MONTGOMERY COUNTY PLANNING DEPARTMENT
THE MARYLAND-NATIONAL CAPITAL PARK AND PLANNING COMMISSION

REVIEW TYPE: Preliminary Plan of Subdivision

PROJECT NAME: Weaver Property

CASE #: 120090160

Figure A.

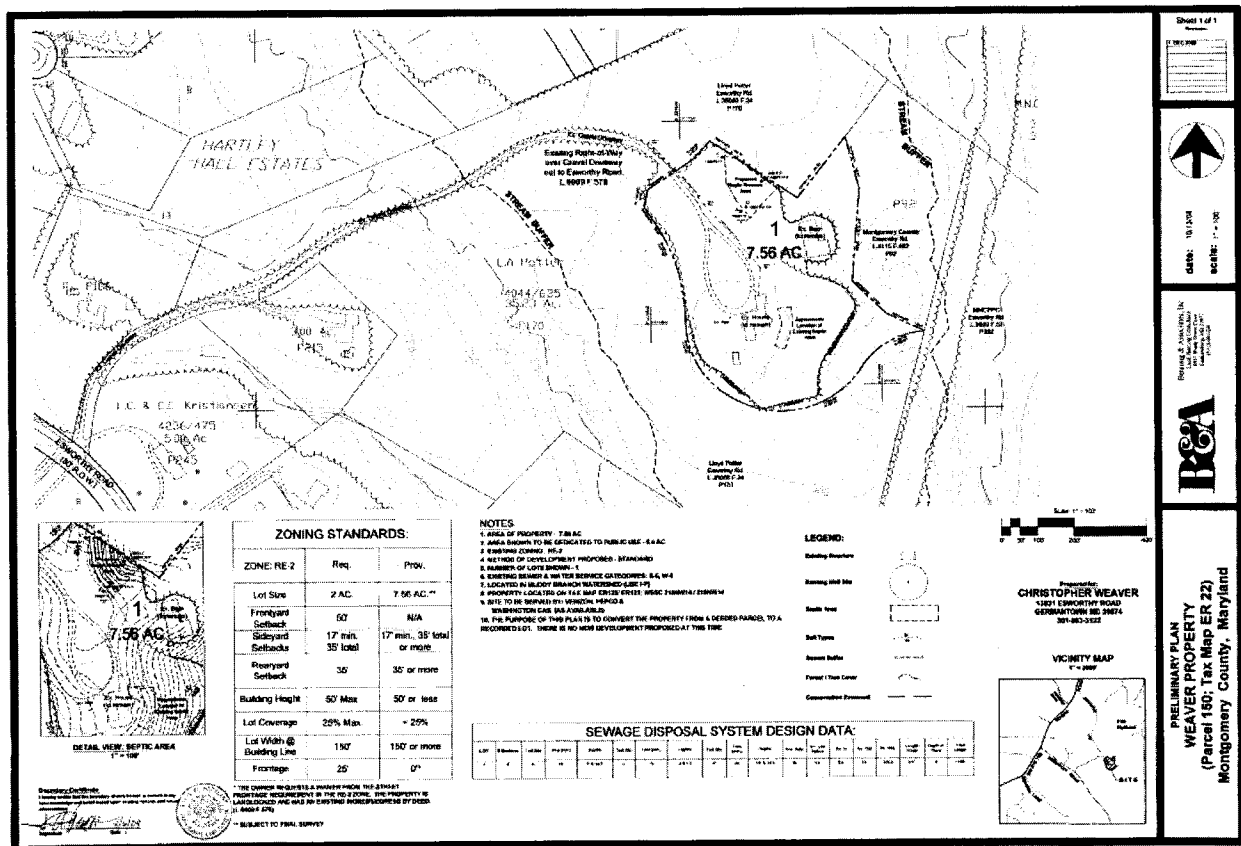
The Applicant proposes to plat the existing parcel in its current configuration. The house on the Property will remain but by platting the parcel, it allows an eventual building permit to be issued for repair, addition or replacement of the house. As mentioned above, the parcel has no frontage on a public street, and as such, a finding of safe and adequate access for a lot with no frontage has been requested by the Applicant and is supported by staff.

The application is recommended for conditional approval; however, staff notes that per the recommended conditions of approval, a revision to the preliminary forest conservation plan is required. The Applicant disagrees with the staff's determination that certain areas of forest on the Subject Property cannot be counted as saved forest. Because of how this affects the forest conservation worksheet, the Applicant would be required to afforest a portion of the Property to meet the threshold requirements of the Montgomery County Forest Conservation Law. A discussion of this issue follows in the Environment Section – Forest Conservation.

The preliminary forest conservation plan, as currently proposed, contains three areas of forest remnants which do not meet the minimum size or composition standards, as defined in Chapter 22A, the Montgomery County Forest Conservation Law. Section 22A-3 defines forest as: a biological community dominated by trees and other woody plants (including plant communities, the understory, and forest floor) covering a land area which is 10,000 square feet or greater and

is at least 50 feet wide. Even though the on-site remnants are contiguous to on-site forest or off-site forest on adjacent Parcel 170, (Potter property), they are too narrow and/or of such poor composition as standalone forest to be saved and credited as such on the forest conservation worksheet. Although the plan does not show any physical removal of trees/forest, these three remnants must be counted as “cleared” forest under the Law. This results in a planting requirement for the Applicant who disputes this determination and has requested Planning Board consideration of this issue.

The most notable of the three remnants is the strip of forest edge along the southern boundary of the Property where it is contiguous to the Potter property. In actuality, the forest shown here on the Subject Property is an extension of the canopy from the forest on the Potter property, not actual tree trunks. Although the strip is forest, as shown on the approved Natural Resource Inventory/Forest Stand Delineation (NRI/FSD) and FCP, it cannot qualify as forest save unless it is protected with the larger forest on the Potter property. Since the Potter property is under private ownership and has not been subdivided, the forest on it is not protected. Although Parcel 170 (Potter) is within the Park desire line for the Muddy Branch Stream Valley Park, the *potential* for public acquisition is not a guarantee of permanent protection of the forest resource on the property. A certain potential exists for this forest to be cleared as part of a subdivision of the Potter property with perhaps acquisition/protection of only the most environmentally sensitive forest in the stream valley buffers. Therefore, staff has resisted placing a permanent Category I easement on the forested strip on the Subject Property because it is not part of a larger, protected off-site forest. If the adjacent forest on the Potter property were removed, the remnant on the Subject Property would be wiped out, as it is only overhanging canopy.

The other two remnant areas are located adjacent to the existing barn on the Property. To the immediate south of the barn, the forest becomes too narrow and of such poor composition to be included in the saved area. To the north of the barn, a finger of forest becomes less than 50 feet wide; without protected forest on the adjacent Potter property it also cannot be counted as saved.

It is staff's position that the currently proposed PFCP does not meet the minimum standards of Chapter 22A, and that compliance with the conditions recommended above is necessary to assure compliance. Staff finds that compliance with the conditions of approval for the preliminary FCP will bring this plan into conformance with Chapter 22A.

- a) Revise the preliminary forest conservation plan to:
 - i) Show all remnant forest areas as cleared on the forest conservation worksheet, as some areas are below minimum size requirements, and

- ii) Provide mitigation for forest loss using off-site options, including offsite planting and forest mitigation banks, but excluding fee-in-lieu.
 - b) Approval of final forest conservation plan consistent with the approved preliminary forest conservation plan prior to any clearing, grading or demolition on the site.
